# UNITED STATES PATENT AND TRADEMARK OFFICE

APPLICATION NO.	FILING DATE	FIRST NAMED INVENTOR	ATTORNEY DOCKET NO.	CONFIRMATION NO.
10/715,412	11/19/2003	Toshiro Kobayashi	2003-1495A	5320

**Office Action Summary**

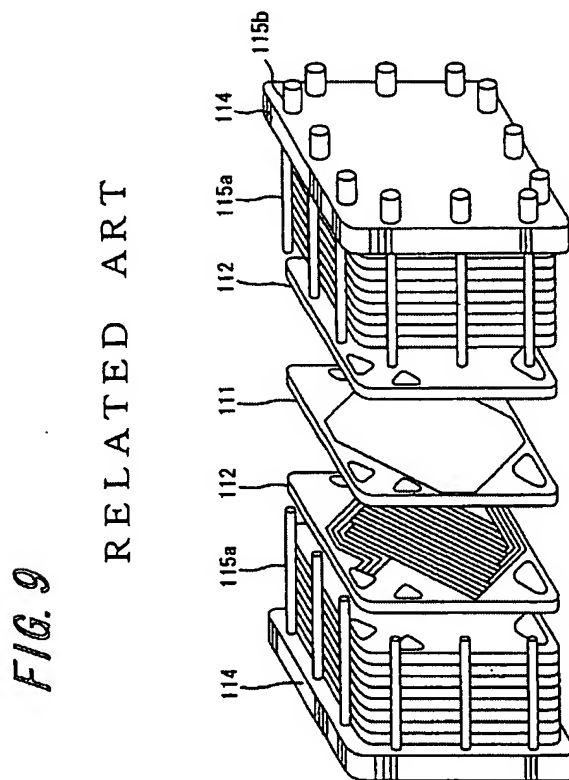
The AAPA illustrates in **Figure 9** below a stacked fuel cell comprising many cell films 111 and many separators 112 stacked alternately; the cell films 111 each comprising a solid polymer electrolyte film sandwiched between electrode films; the separators 112 each having electrical conductivity and having a fuel gas channel formed in one surface thereof and an oxidant gas channel formed in the other surface thereof (Applicant's Background of the Invention, paragraph bridging pages 1-2).

**(Emphasis furnished→)** The AAPA reveals that the periphery of the resulting stack is clamped by threaded shafts 115a and nuts 115b via end plates 114. Shafts 115a pass through

piercing portions (*penetrate through holes or make a way through the holes*) of the many separators 112 interposed therebetween and end plates 114 (Applicant's Background of the Invention, paragraph bridging pages 1-2). *Note that shafts 115a is accommodated at a direction  $\perp$  to the stacking direction of cell films 111 (See FIGURE 9). Shafts 115a and nuts 115b comprise at least the line-shaped fastener. In this case, either the separators themselves or the end plates can be interpreted as the plurality of partition plates.*

The AAPA discloses many separators 112 and end plates 114 (Applicant's Background of the Invention, paragraph bridging pages 1-2/ See FIGURE 9). *In the instant case, under a first interpretation, the combination of a separator plate and an plate corresponds to the partition plate and the terminal board, respective. Thus, they acts as first and second members. Under a second interpretation, any separator plate itself may be the end separator and the terminal board. Reason why, applicant's embodiment of Figure 7b contemplates an integrated separator and a terminal board. Thus, the disclosed separator of the AAPA can be taken as the integrated separator and terminal board because there is no specific limitation in claim 3 to require that the separator and the terminal be separated.*

The AAPA reveals that the periphery of the resulting stack is clamped by threaded shafts 115a and nuts 115b via end plates 114. Shafts 115a pass through piercing portions (*penetrate through holes or make a way through the holes*) of the many separators 112 interposed therebetween and end plates 114 (Applicant's Background of the Invention, paragraph bridging pages 1-2). *Shafts 115a and nuts 115b comprise at least the line-shaped fastener which fast together the cells 111 and separators 112.*

The AAPA discloses that if any of the cell films 111 is damaged for some cause and needs to be replaced in the stacked fuel cell; the threaded shafts 115a and the nuts 115b are detached and the damaged cell film 111 is replaced by a new cell film 111, whereafter the cell film 111 and the separators 112 are clamped again by the threaded shafts 115a and the nuts 115b

via the end plates 114. Thus, in this manner, maintenance and management are performed (Applicant's Background of the Invention, page 2, 1<sup>st</sup> full paragraph). *Thus, the AAPA at once envisages fastening the cell films 111, unfastening them if one cell becomes damaged (targeted cell), and replacing (detaching) such a damaged cell.*
